Well Name: JOHN DENVER 15/14 FED COM	Well Location: T18S / R29E / SEC 15 / SWSW /	County or Parish/State: /
Well Number: 526H	Type of Well: OIL WELL	Allottee or Tribe Name:
Lease Number: NMNM0437524	Unit or CA Name:	Unit or CA Number:
US Well Number: 3001554412	Well Status: Drilling Well	Operator: MEWBOURNE OIL COMPANY

Notice of Intent

Type of Submission: Notice of Intent	Type of Action: APD Change
Date Sundry Submitted: 11/27/2023	Time Sundry Submitted: 11:03
Date proposed operation will begin: 12/01/2023

Procedure Description: Mewbourne Oil Company request that the following change be made to the John Denver 15/14 B2LI Fed Com #1H (APD ID # 10400084742): 1. Change well name f/ John Denver 15/14 B2LI Fed Com #1H (APD ID # 10400084742) to John Denver 15/14 Fed Com #526H. 2. Attached Plat with new well name. 3. Request a variance to perform break testing and offline cementing per attachments. 4. Attached Break Testing and Offline Cementing variance.

Figure 1. BOP diagram

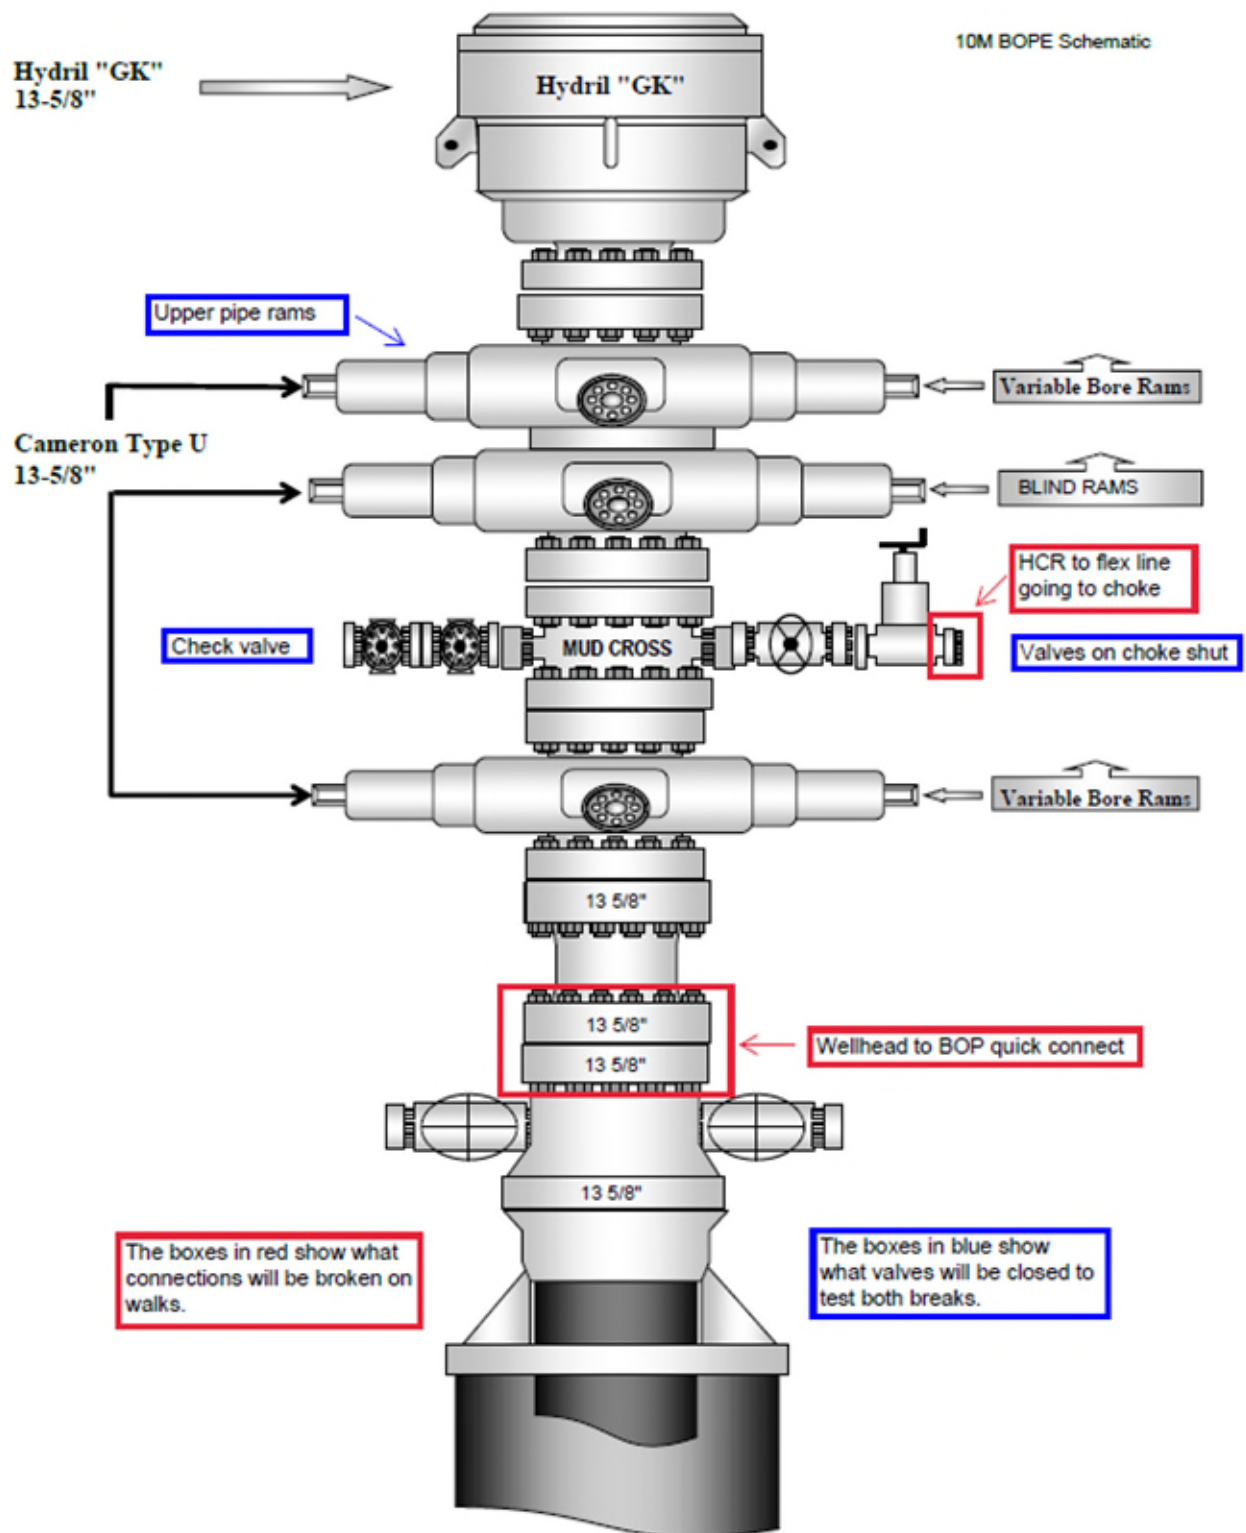
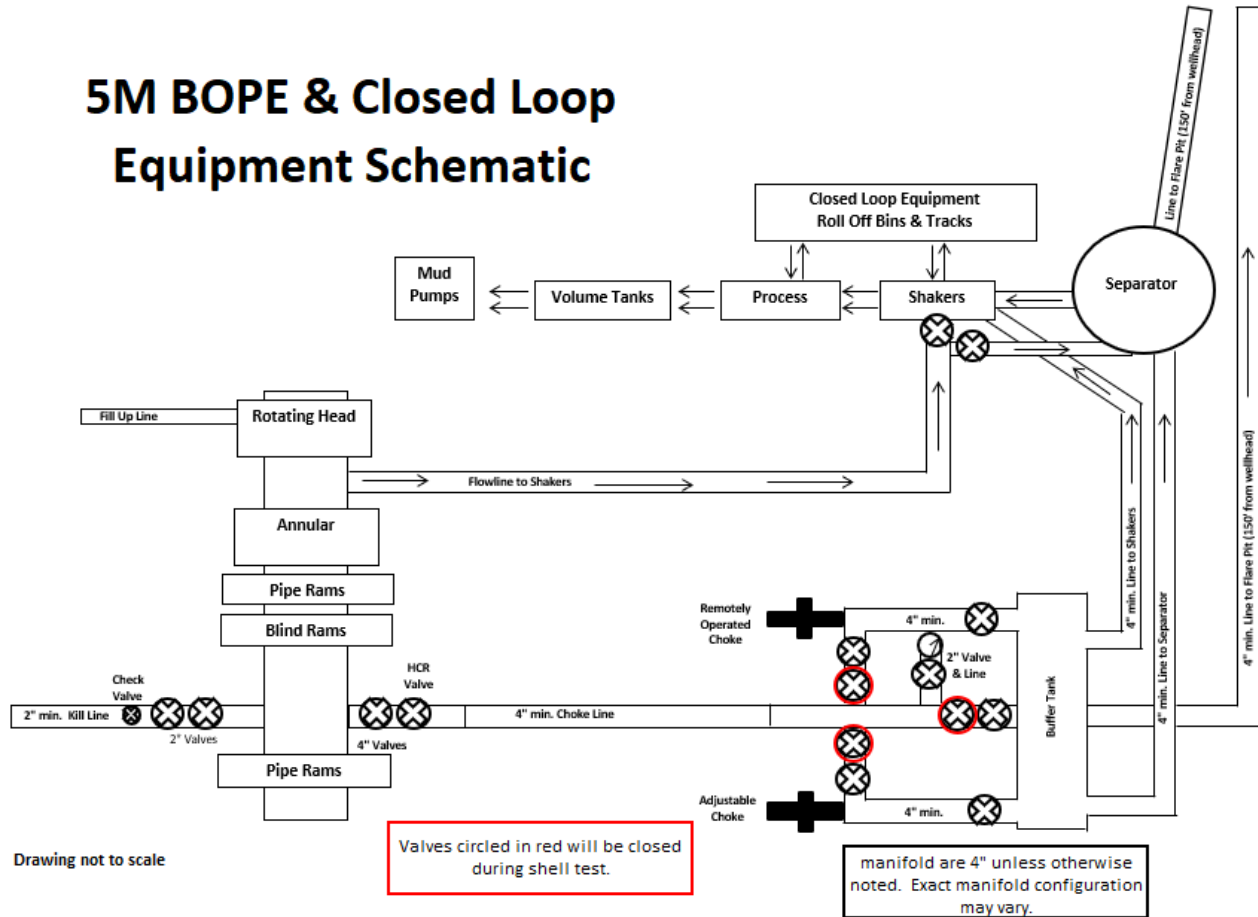
2. After the well section is secured and the well is confirmed to be static, the BOP will be disconnected from the wellhead and walked with the rig to another well on the pad. Two breaks on the BOPE will be made (Fig. 1).

9. A test will then be conducted against the upper pipe rams and choke, testing both breaks (Fig. 1 & 2).
10. The test will be held at 250 psi low and to the high value submitted in the APD, not to exceed 5000 psi.

Figure 3. BOP handling system

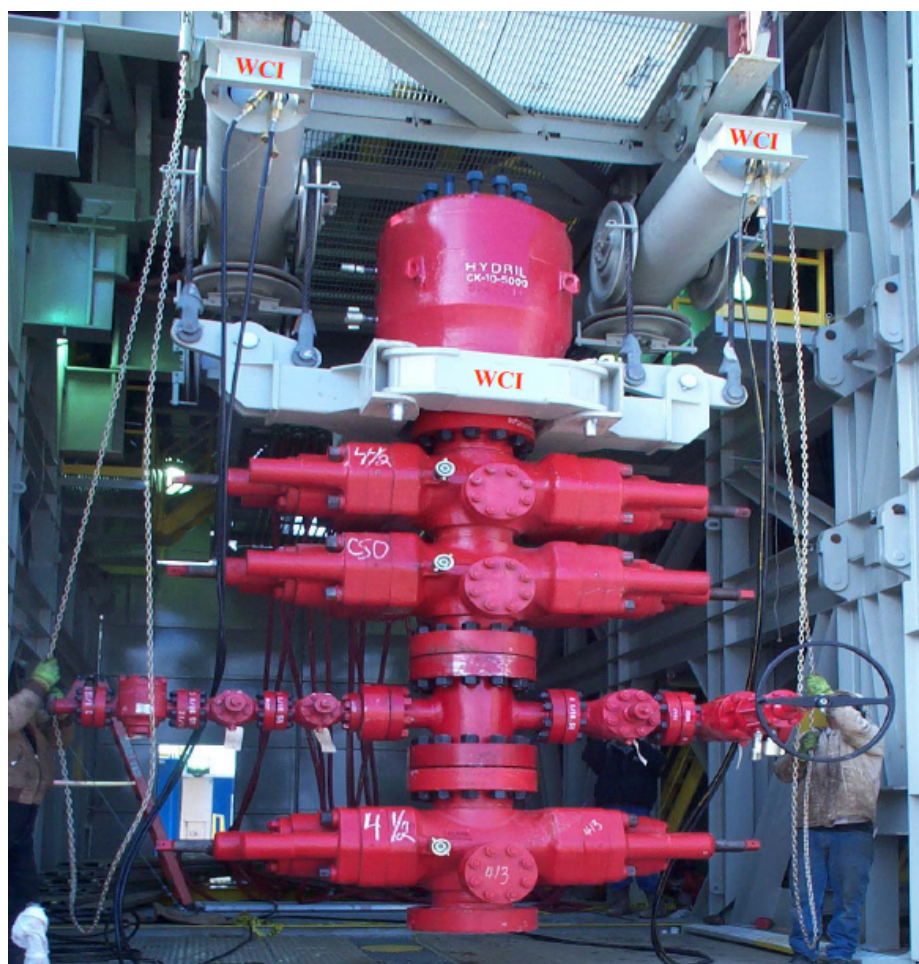
4. The BOP will be removed and carried by a hydraulic carrier (Fig. 3 & 4).
5. The rig will then walk to the next well.
6. Confirm that the well is static and remove the capping flange.

Figure 5. Cactus 5M wellhead with BOP quick connect

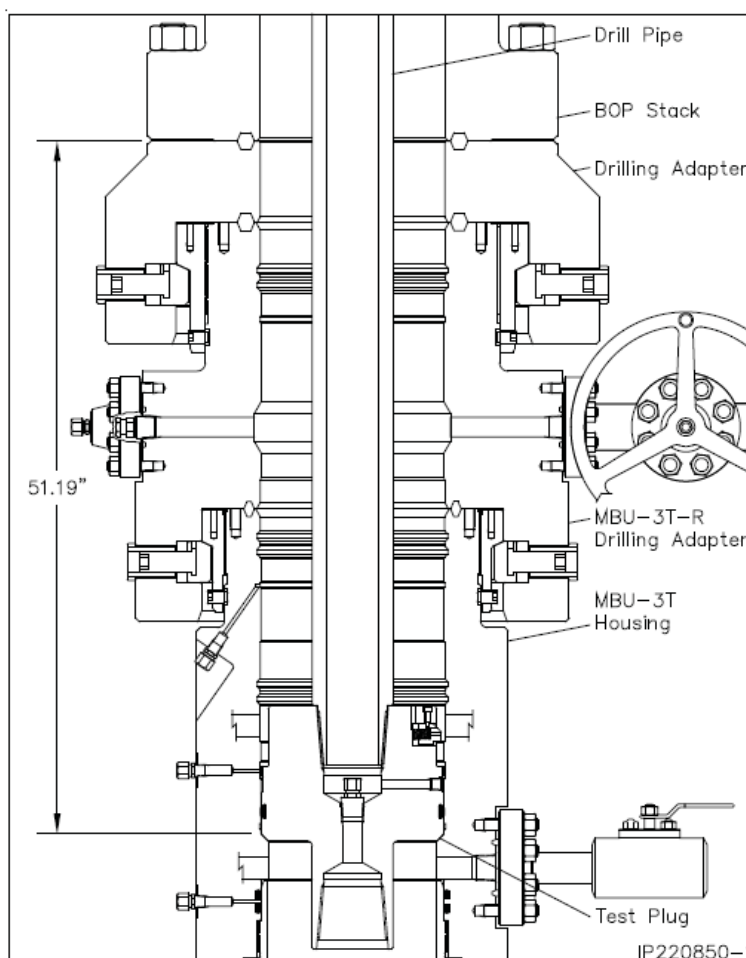
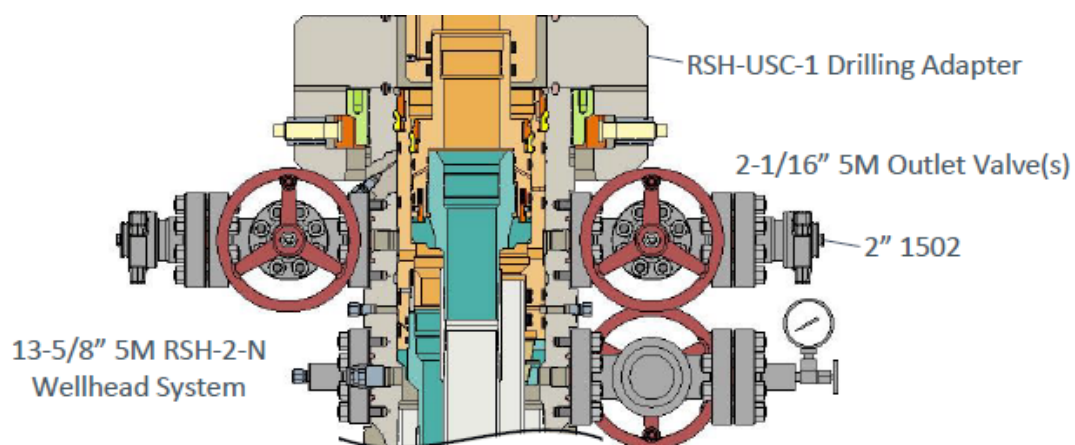
- Connection between the flex line and the HCR valve
 - Connection between the wellhead and the BOP quick connect (Fig. 5 & 6).
3. A capping flange will be installed after cementing per wellhead vendor procedure & casing pressure will be monitored via wellhead valve.
